PRELIMINARY OVERALL AREA DEVELOPMENT PLAN

THE OAKS OF WESTCREEK-UNITS I & II AND ROYAL OAKS OF WESTCREEK-UNITS I & II

FILE NO. #86-08-58-62
(To be assigned by the Planning Dept.

RE: Oaks of Westcreek and Royal Oaks of Westcreek POADP
File # 86-08-58-62

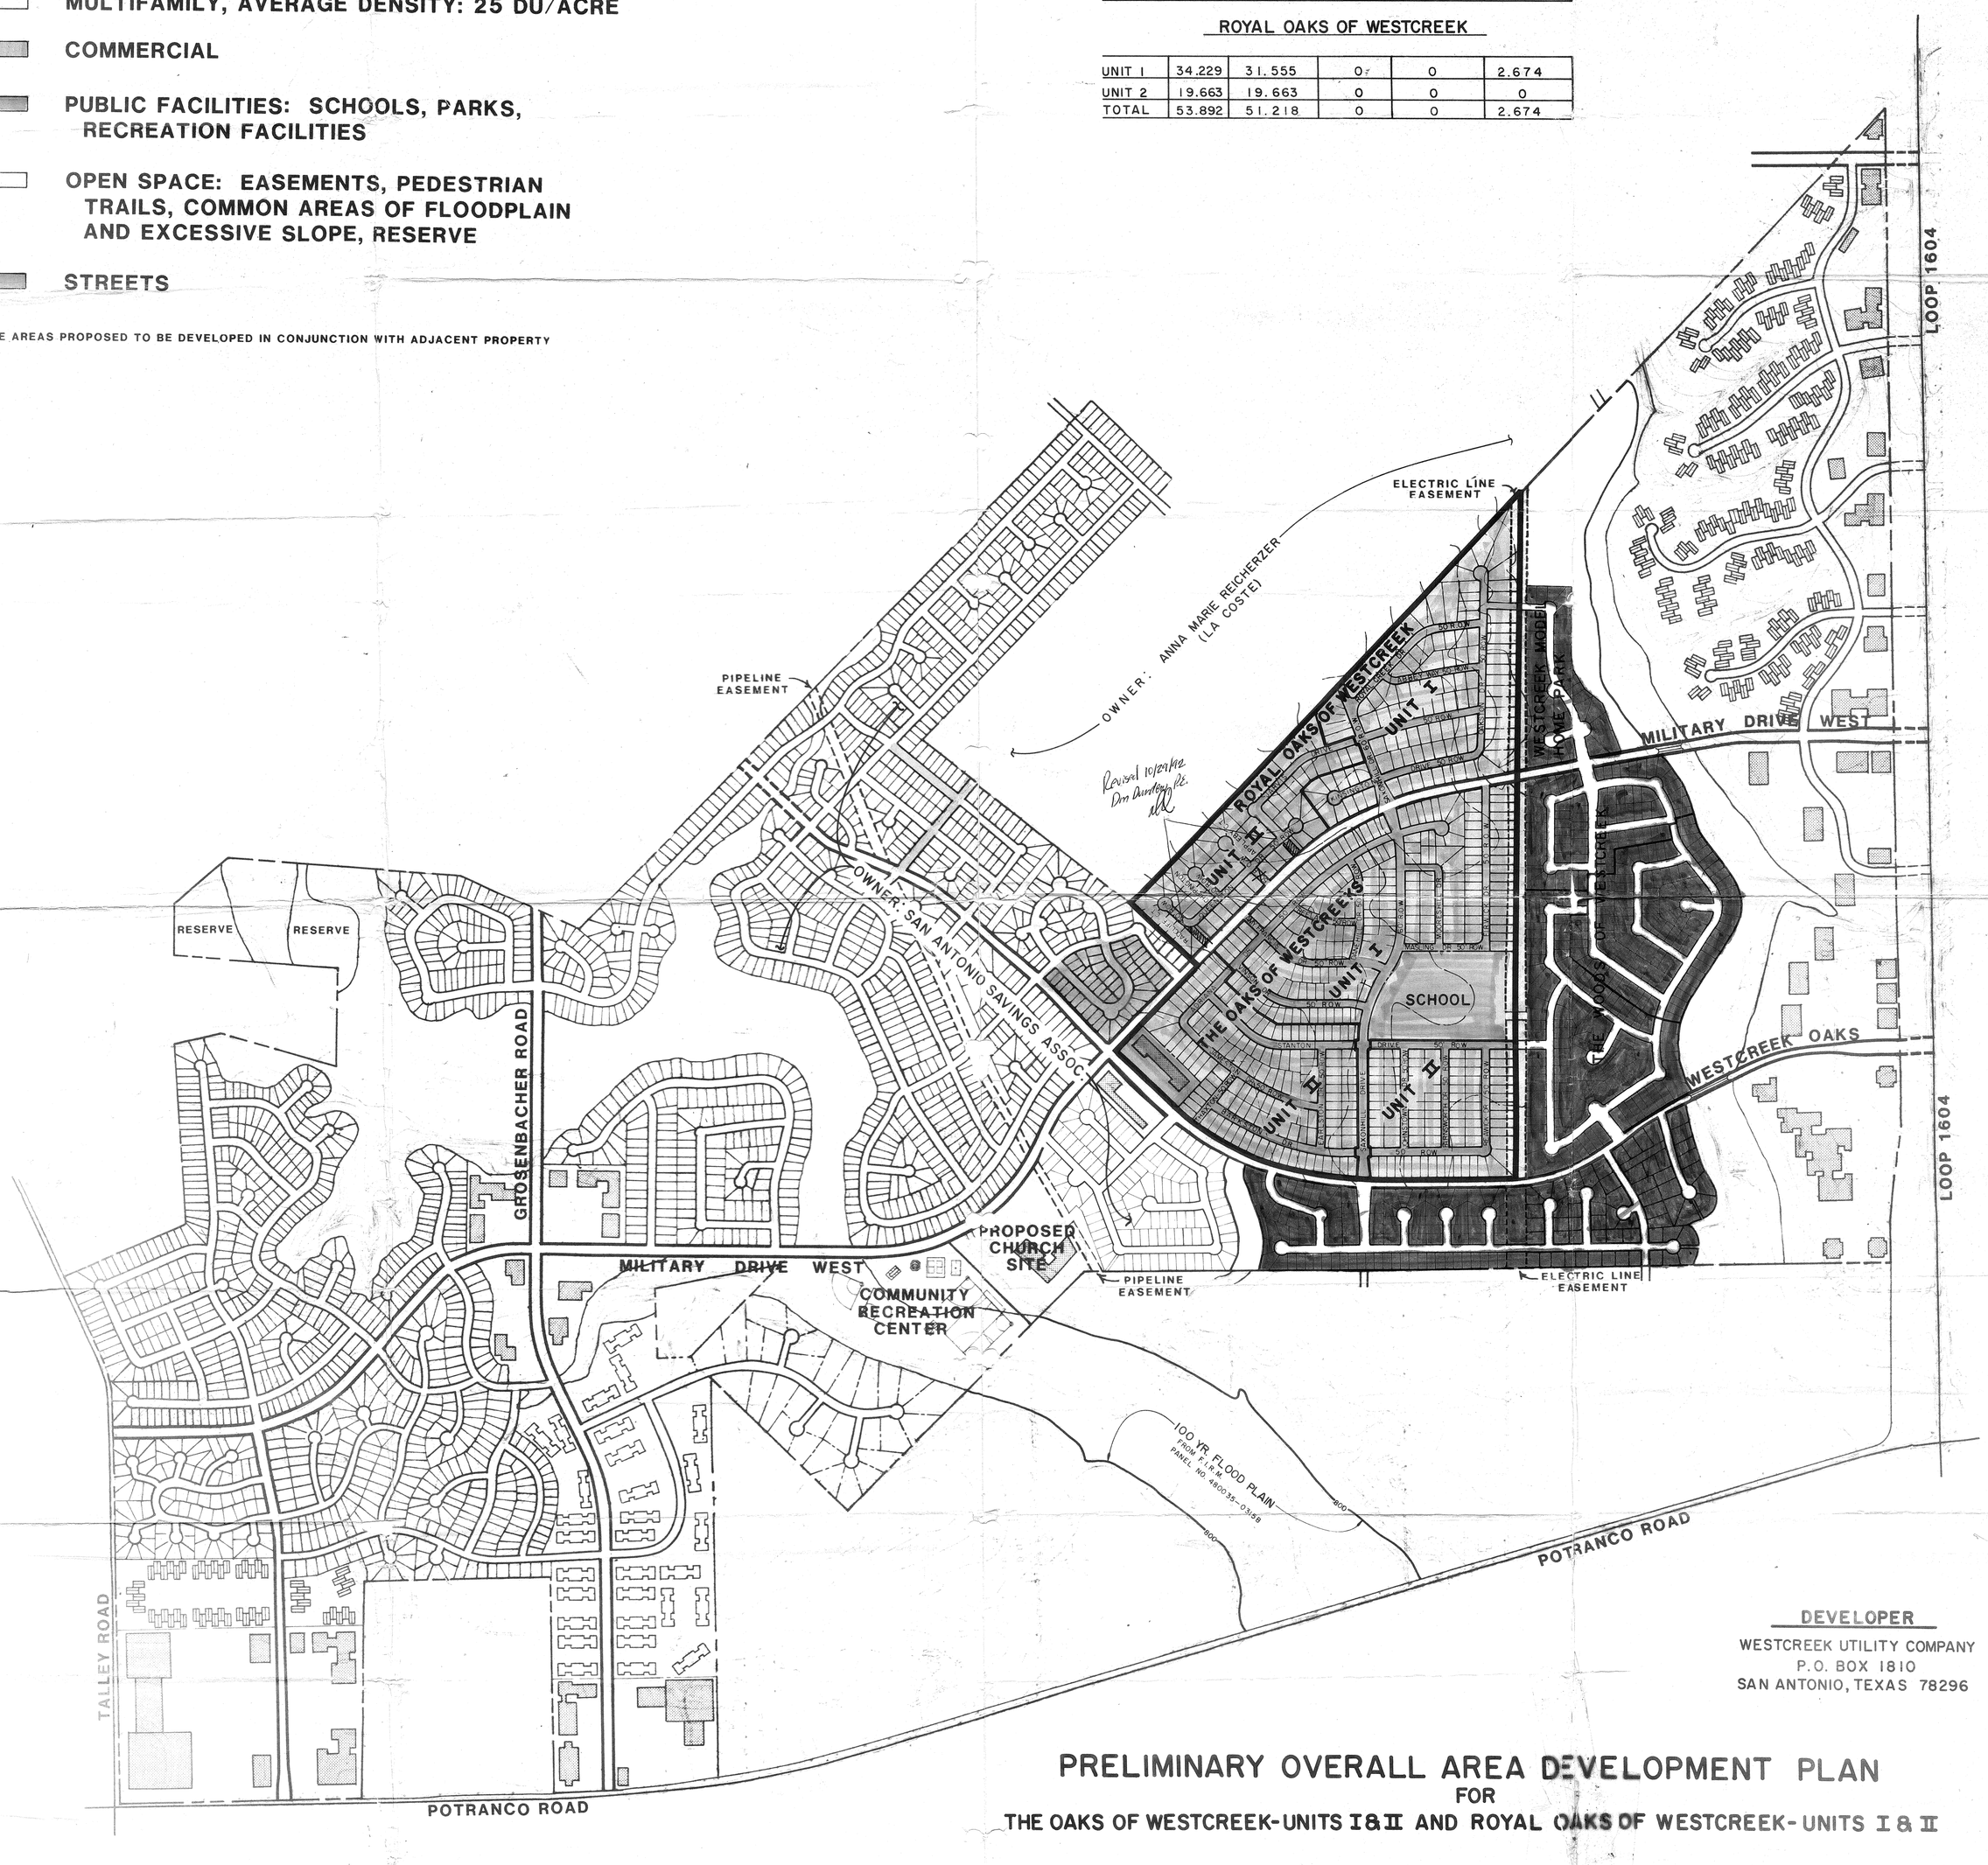
This is to inform you that the POADP committee has reviewed and accepted your plan of the Oaks of Westcreek and Royal Oaks of Westcreek.

It is noted however, that Stanton Drive and Mashing Drive are less than the Type "B" street as defined in the Subdivision Regulations. Type "B" street is used as secondary access and circulation to community facilities (schools, parks, etc.) and other traffic generators such as commercial and industrial areas. The Traffic Section of the Department of Public Works will have to make a determination upon formal plat filing.
